# **Bunbury Harbour City - Marlston Hill development — proposed changes to environmental conditions**

**Landcorp and the South West Development Commission**

**Report and recommendations  
of the Environmental Protection Authority**

**Environmental Protection Authority  
Perth, Western Australia  
Bulletin 774  
March 1995**

Figure 1. Location of the Bunbury Harbour and City proposal

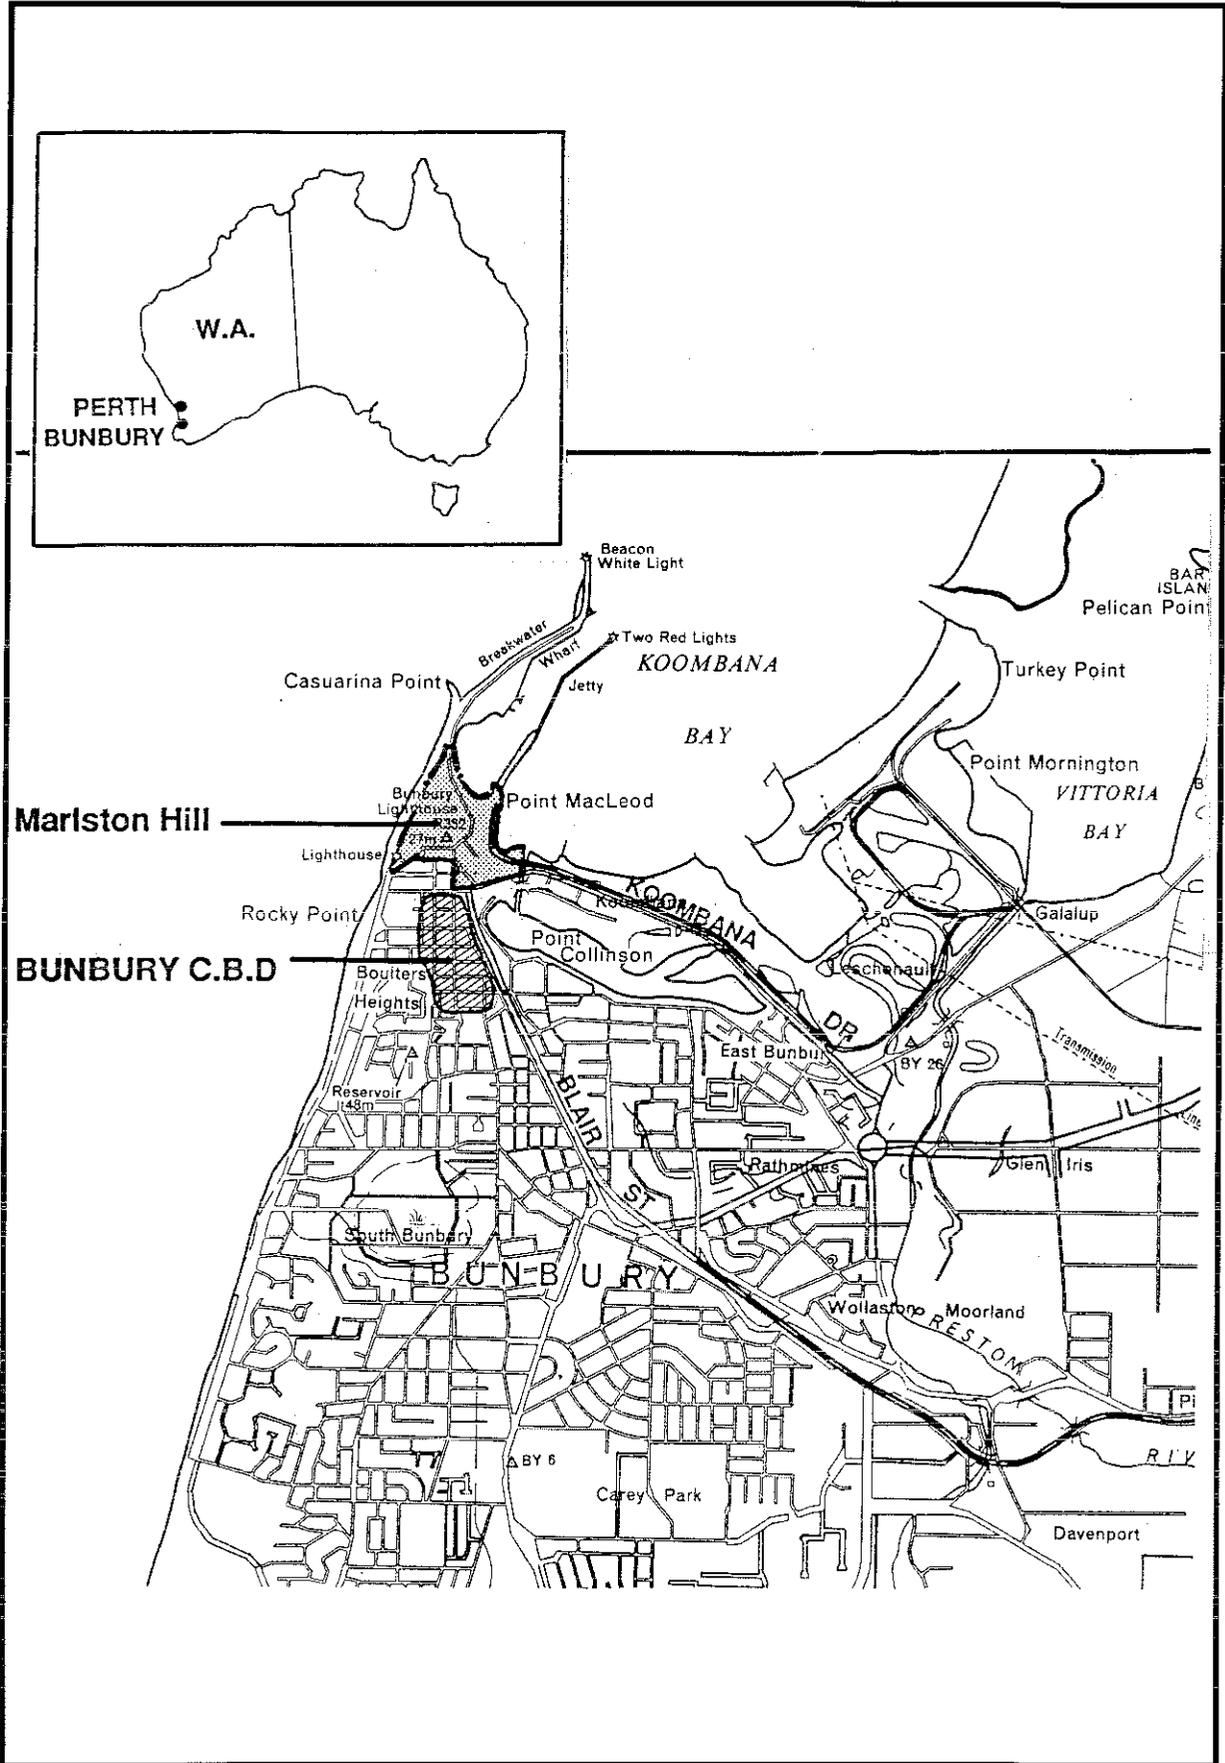
There is conflict between the extent of development indicated by the Locality Plan and by the Precincts Plan. It would be of concern if the proposed Structure Plan were to encompass

Casuarina Boat Harbour as indicated by the Locality Plan. It is understood that this is not the case, and that the Precinct Plan defines the correct limits of the area under consideration.

**Figure 1 - Locality Plan** has been modified to reflect the extent of the development proposed in the Structure Plan. Figure 1 now matches the extent of the development as show in **Figure 2 - Precinct Plan**. The modified figure is attached.

Figure 2. Existing and proposed rezoning

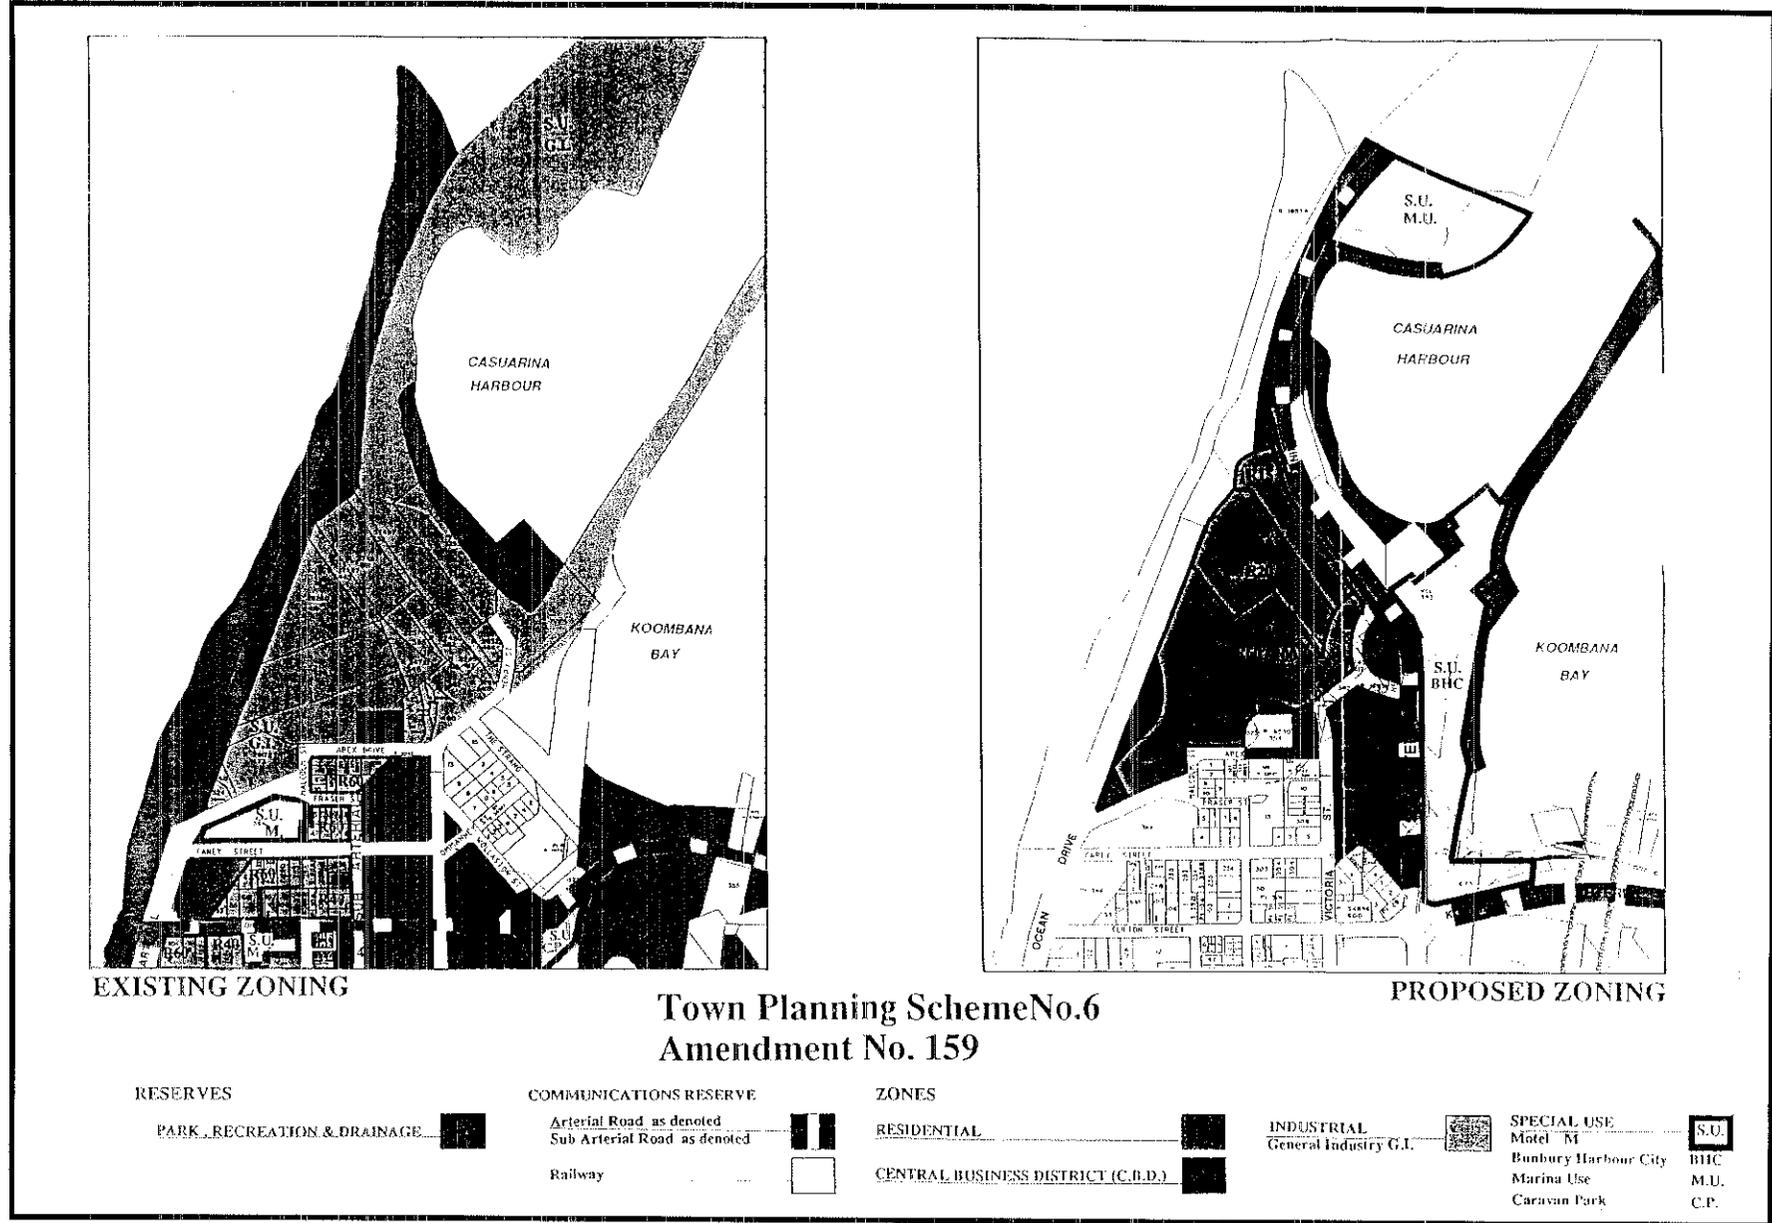
However, the EPA supports the preservation of the railway reserve from Brunswick Junction to central Bunbury because of the long term greenhouse gas reduction, energy conservation and public transport benefits, and notes that a rail reserve is included within the Proposed Zoning in Figure 2.

The EPA therefore supports the preservation of the railway reserve from Brunswick Junction into Central Bunbury because of the long term greenhouse gas reduction, energy conservation and public transport benefits, and notes that a rail reserve is included within the Proposed Zoning in Figure 2.
